# UNITED STATES PATENT AND TRADEMARK OFFICE

APPLICATION NO.	FILING DATE	FIRST NAMED INVENTOR	ATTORNEY DOCKET NO.	CONFIRMATION NO.
10/825,028	04/15/2004	Steven V. Jones	BR8843	7480
28268	7590	07/03/2006	EXAMINER	
THE BLACK & DECKER CORPORATION 701 EAST JOPPA ROAD, TW199 TOWSON, MD 21286			SHARP, JEFFREY ANDREW	
			ART UNIT	PAPER NUMBER
			3677

### **DETAILED ACTION**

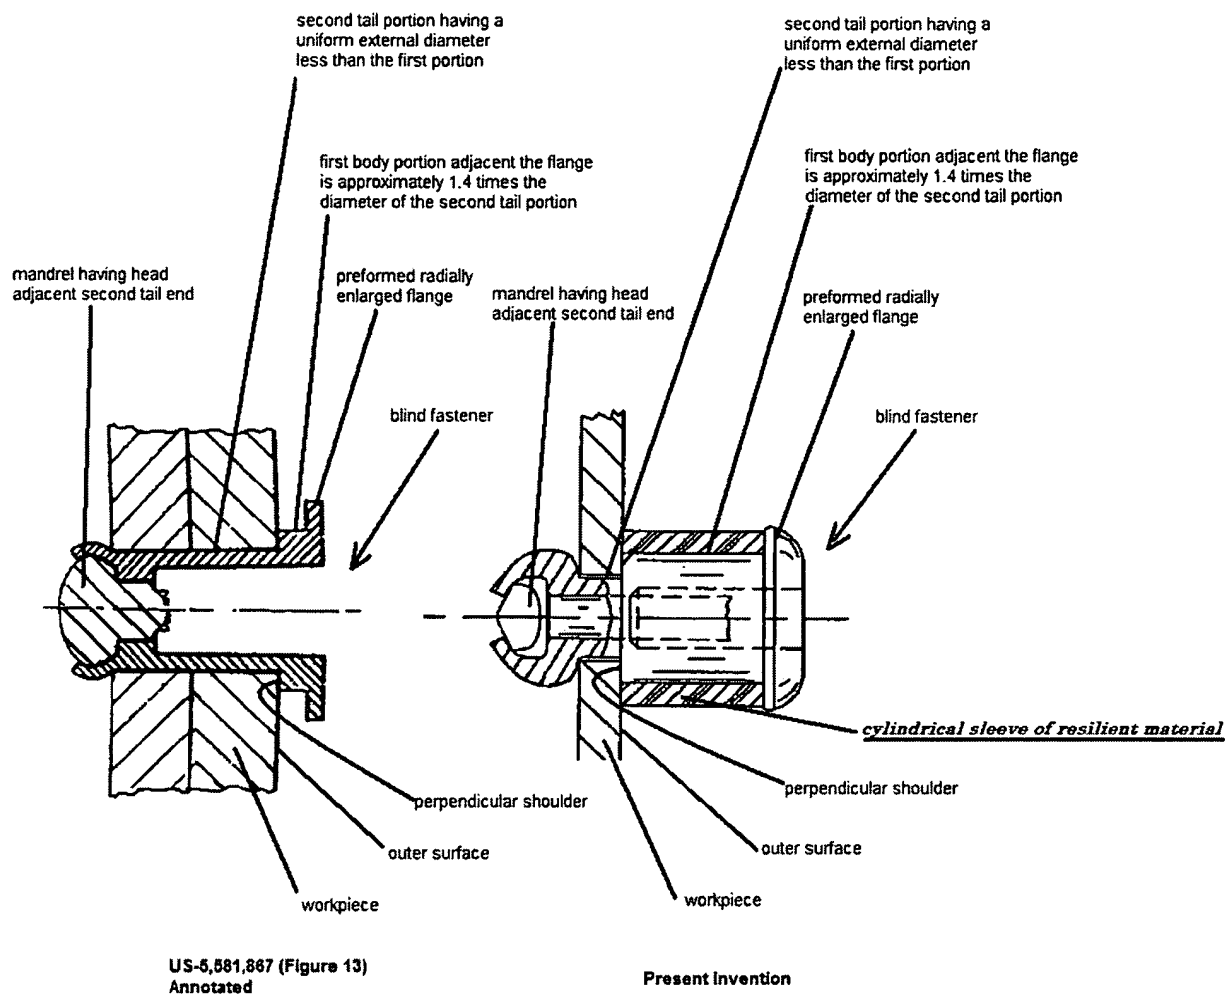
In short, Gaquere teaches or at least suggests each and every limitation found in claims 1-10 and 12-20, except for a "cylindrical sleeve of resilient material", said sleeve "acting as a stop". Examiner has provided a clear comparison of the present invention with base reference Gaquere in the illustration below:

In short, Gaquere teaches or at least suggests each and every limitation found in claims 1-10 and 12-20, except for a "cylindrical sleeve of resilient material", said sleeve "acting as a stop". This is clearly shown above.

**Aasgaard suggests placing a gasket around the body adjacent the outwardly-extending flange in order to provide "additional sealing capability"**

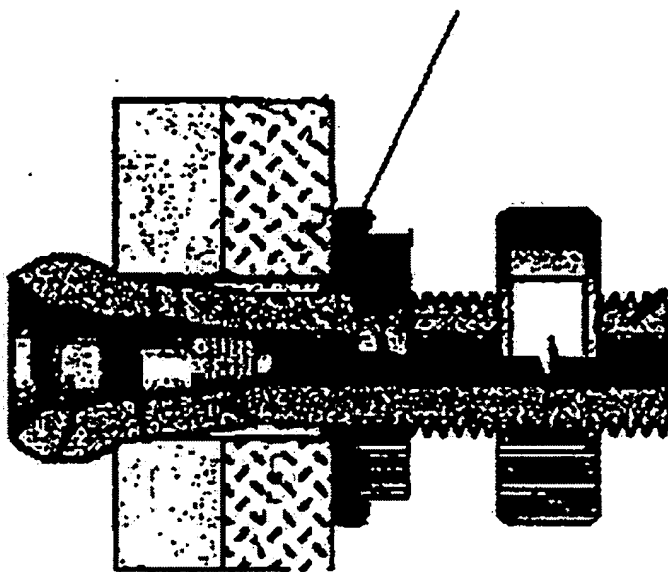
Aasguar suggests a cylindrical sleeve of resilient material around the body of a blind fastener adjacent to a preformed radially enlarged flange, in order to provide "additional sealing capability". This sleeve inherently acts as a (broad) "stop" for at least the radially extending flange, so that the flange is prevented from contacting the workpiece. Aasguar suggests that the material of the cylindrical sleeve is variable, and therefore, one of ordinary skill in the art would be inclined to use any material that is sufficient for sealing.

**Additionally, a washer or gasket 734 made of rubber, vinyl, plastic, or the like may be disposed between the outer work piece 726 and the head 736 of the rivet body 722 to provide additional sealing capability.**

Therefore, at the time of invention, it would have been obvious to one of ordinary skill in the art, to modify the blind fastener taught by Gaquere, to comprise a cylindrical sleeve of resilient material around the body of a blind fastener adjacent to a preformed radially enlarged flange as suggested by Aasgaard, in order to improve the sealing characteristics of the blind fastener. Although Applicant's intended use of the sleeve is to act as a stop for a carrier member, it is not required that the prior art disclose or suggest the properties newly-discovered by an
